Submission 1

Exhibition of State Significant Infrastructure Application Moorebank Avenue Realignment.
Application SSI-10053 Moorebank realignment

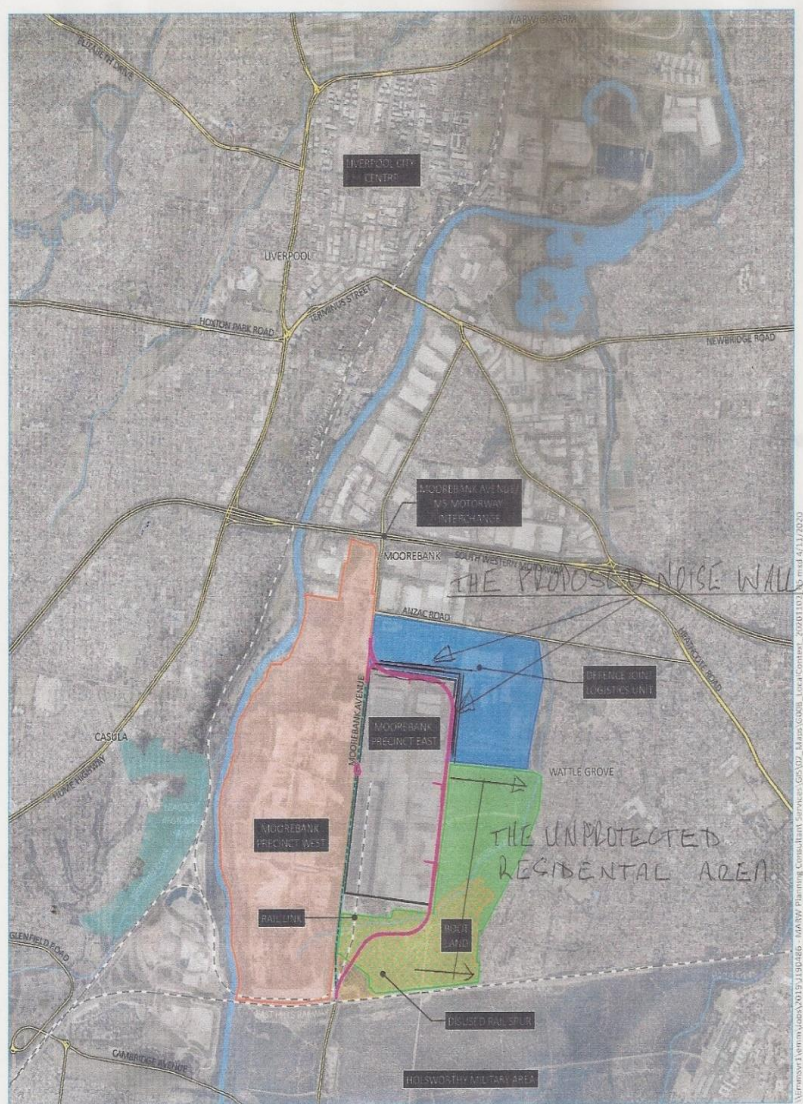
Objection: It is interesting note Qube are prepared to provide noise mitigation to Defence Logistics Unit, from the start of the realigned road from Moorebank Ave to some distance south along the eastern side of the site for approximately one + kilometres.

If Qube are prepared to provide noise protection to the defence site against excessive noise, **they must then be required to do the same to the eastern side Wattle Grove** down some distance past the Southern the boundary of the MPE site.

It should also be noted that the south east end of the realignment will be as close as 400-500 metres to Wattle Grove.

The map on page 3 illustrates the proposed noise mitigation of the Defence Logistics site, together with how close the road will be to the suburb of Wattle Grove.
